**PLAN COMMISSION MEETING
IN PERSON AND VIA ZOOM
TUESDAY, JANUARY 28, 2025 – 4:00 PM
CITY HALL – SECOND FLOOR**

AGENDA

PRELIMINARY PLAT REVIEW REPORT TO THE PLAN COMMISSION

Concept Plan Presentation REPORT TO THE PLAN COMMISSION

PRELIMINARY PLAT
RIDGE VIEW ESTATES
SHEET 1 OF 3
QUAM ENGINEERING, LLC
Residential and Commercial Site Design Consultants

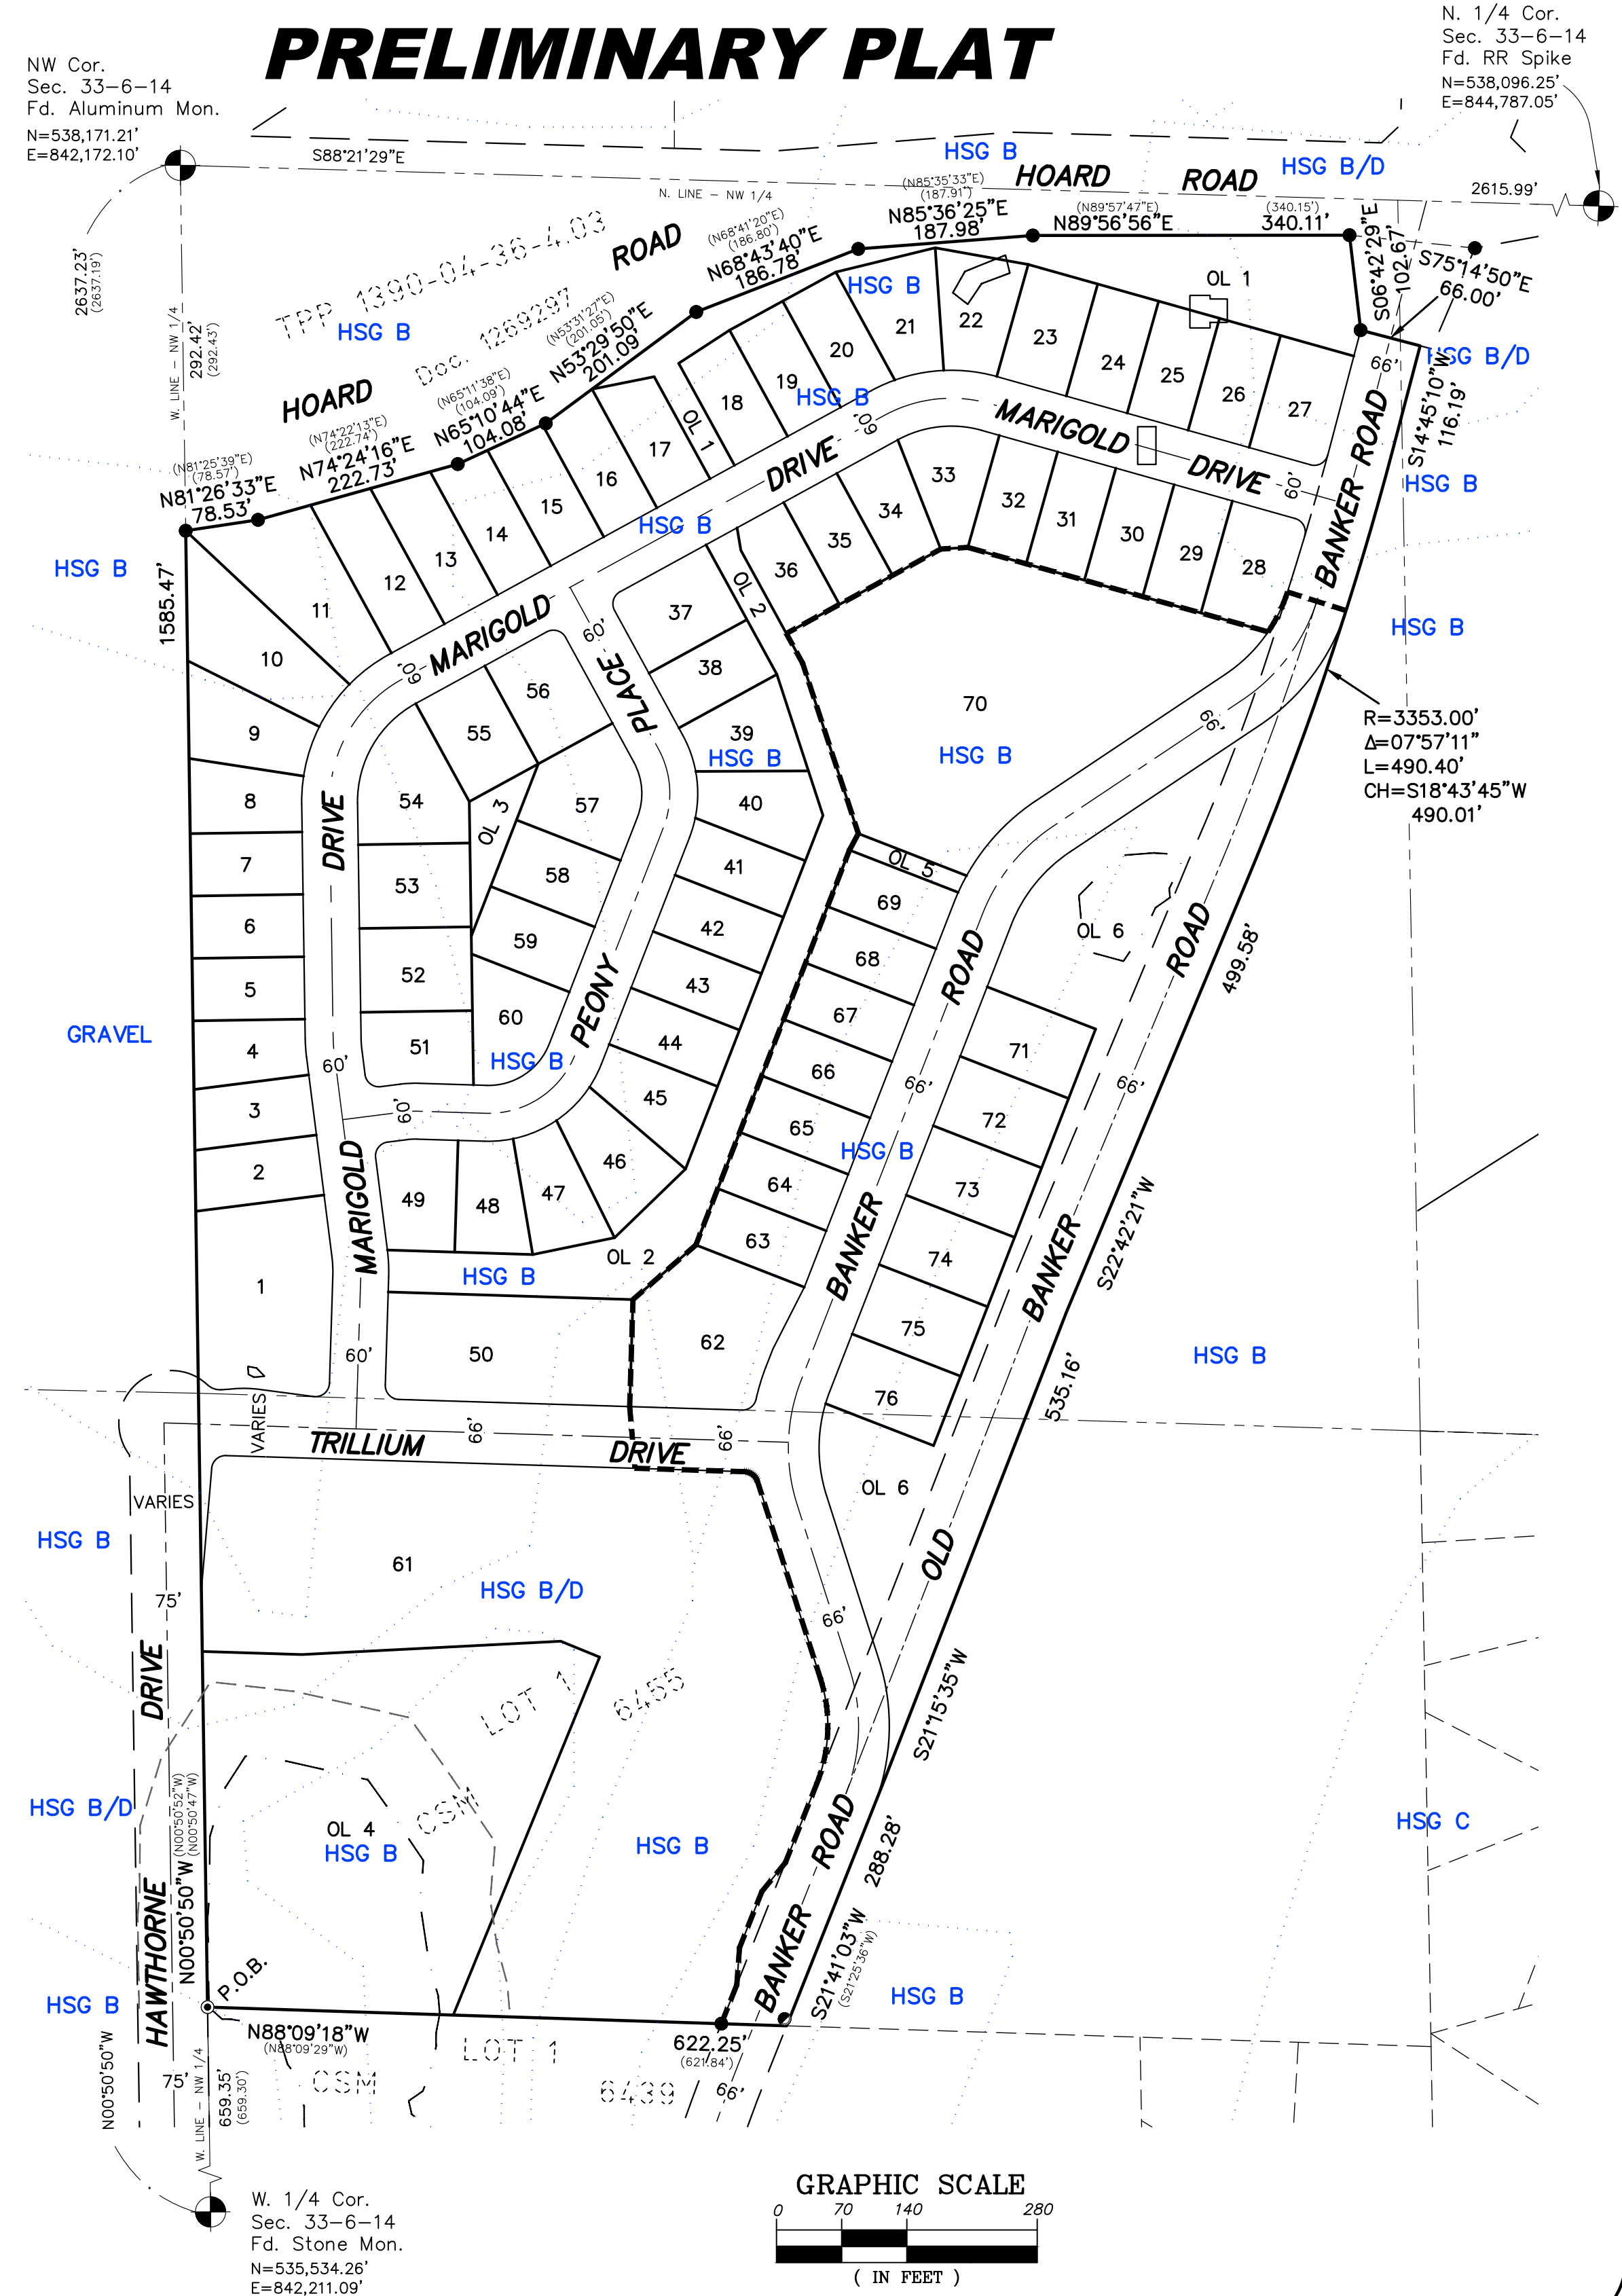
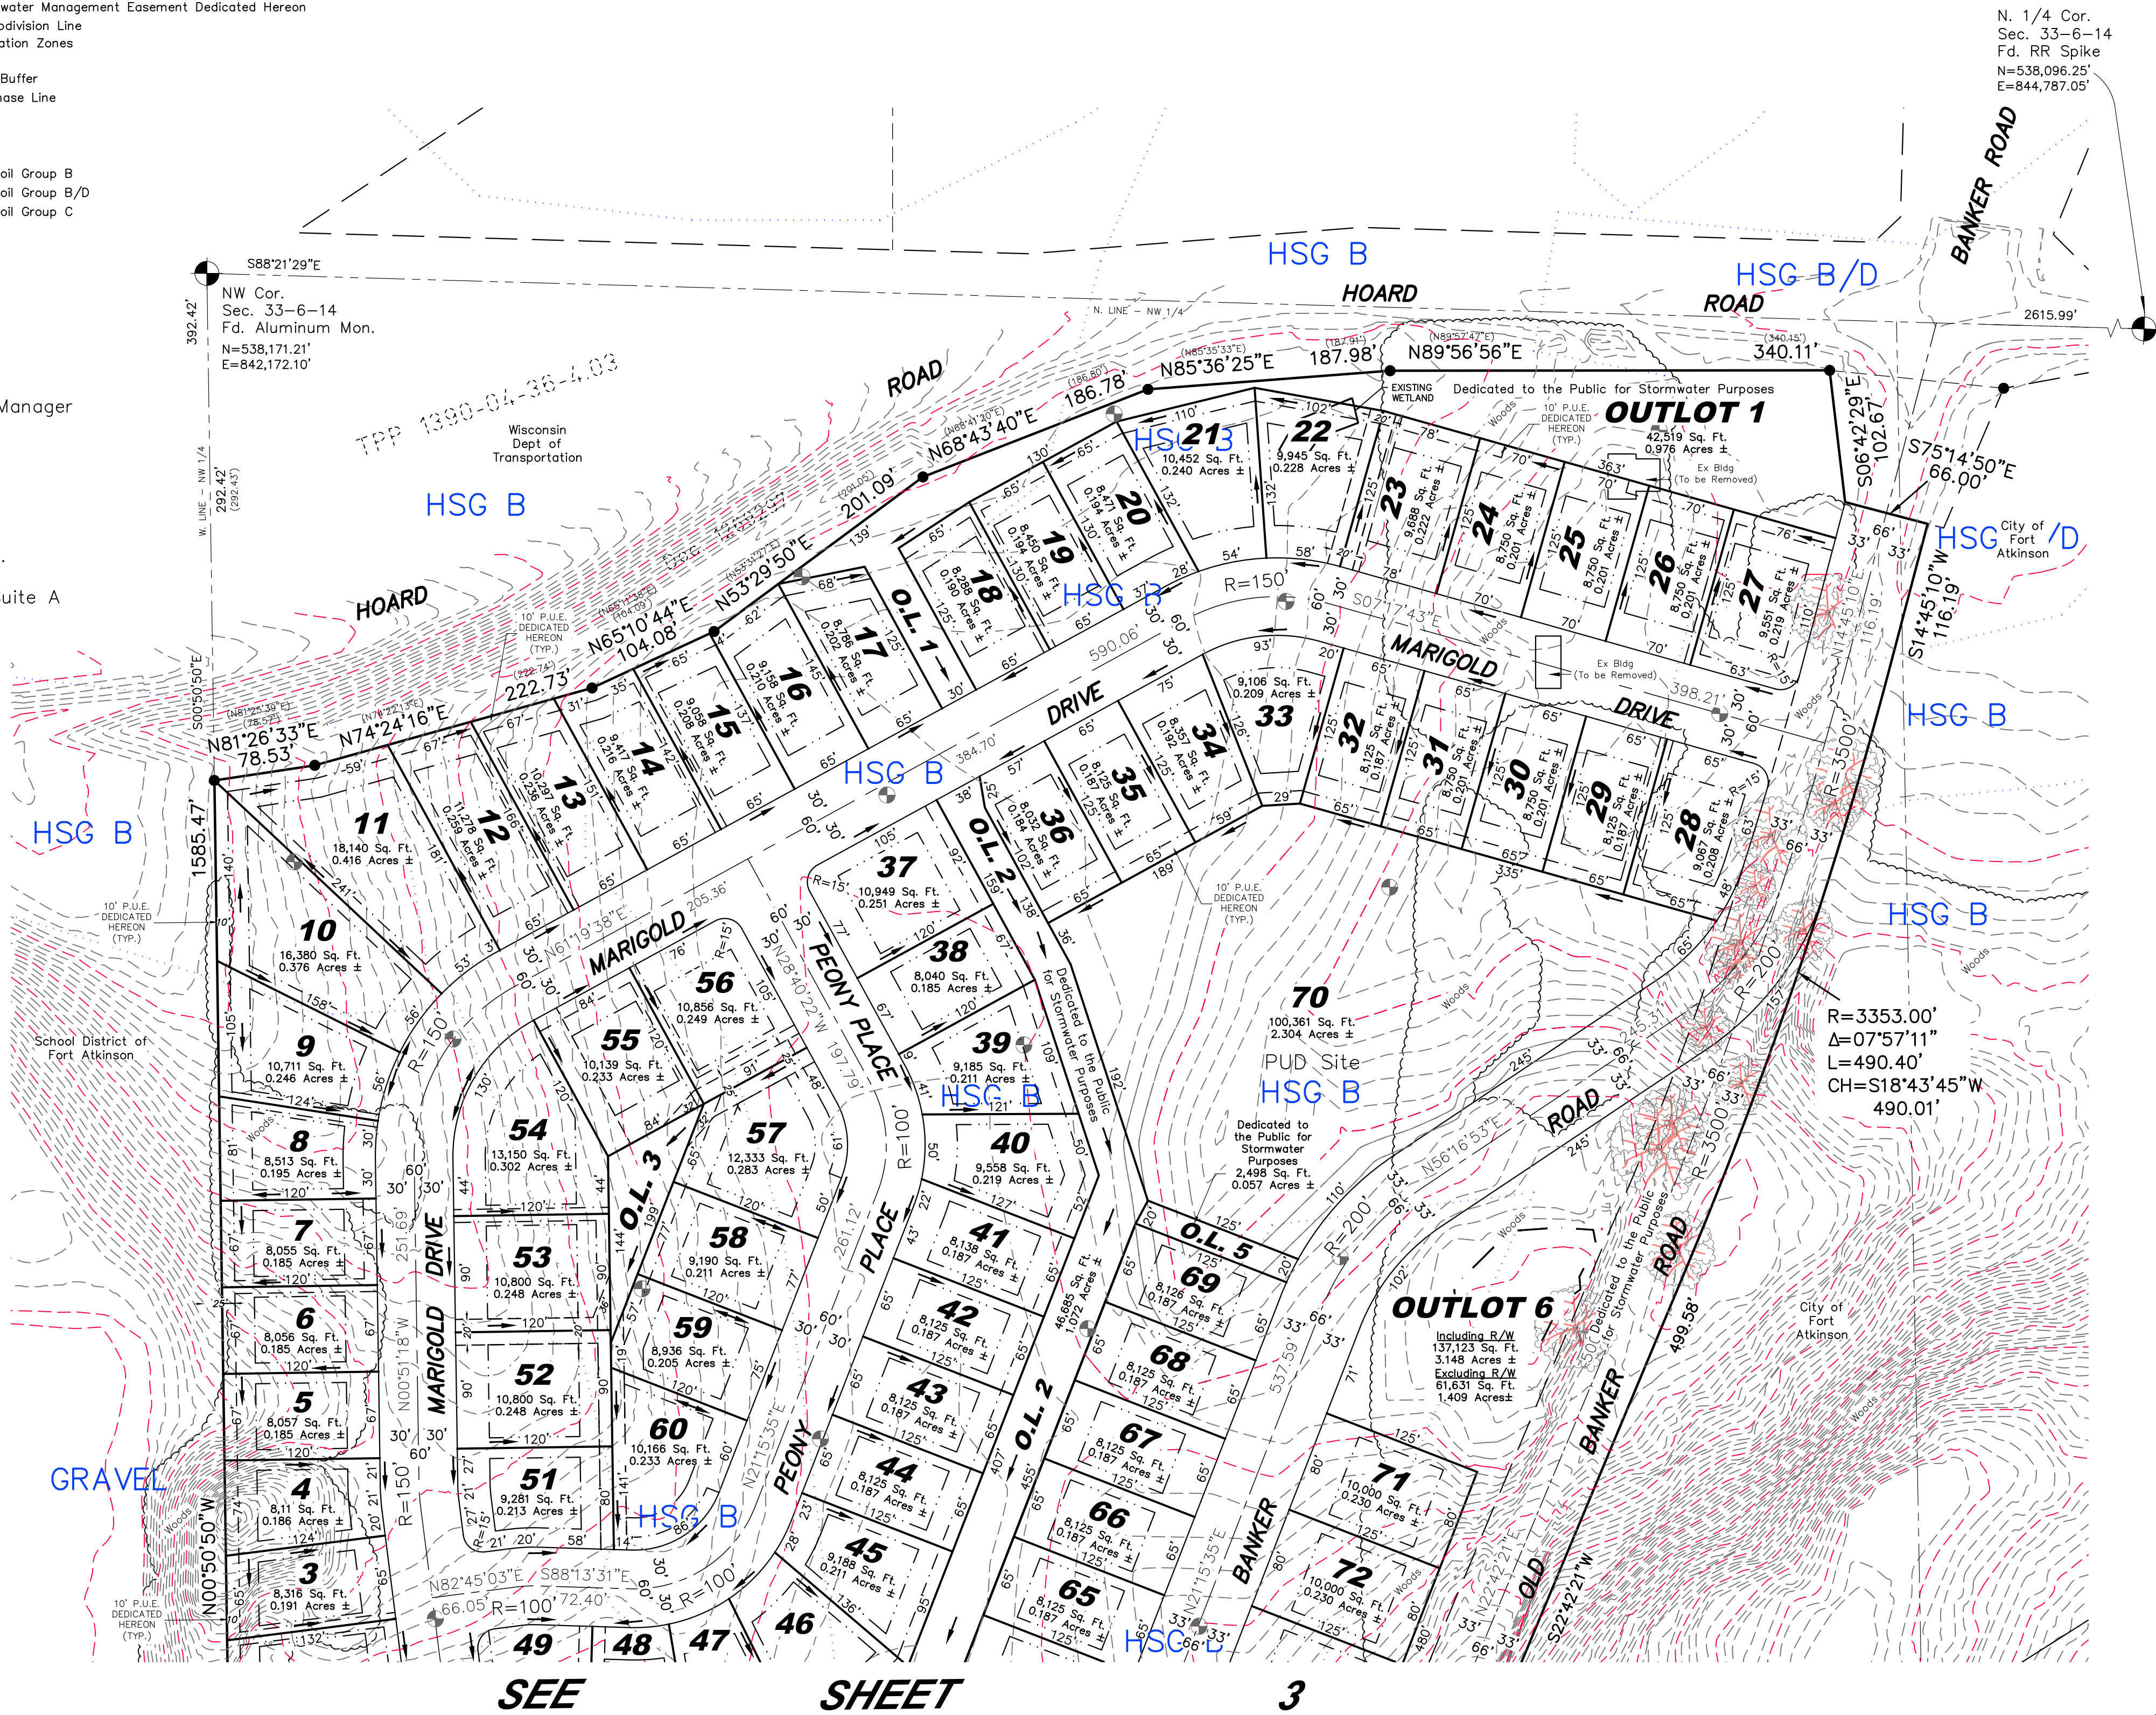
City staff recommends the Plan Commission recommend the City Council approve the Preliminary Map with the conditions listed below:

1. PUD lots to be labeled with each individual lot's base Zoning
2. Outlot 2 to be eliminated and replaced with stormwater easements; bringing all proposed lots into conformity with respect to dimensions
3. Outlot 3 to be eliminated to accommodate changes in road grading per the Design Engineer
4. Utility easements to be shown on Final Plat
5. Set all collector street radius' to city standards
6. Outlots to be described or labeled as CON - Conservancy on Final Plat
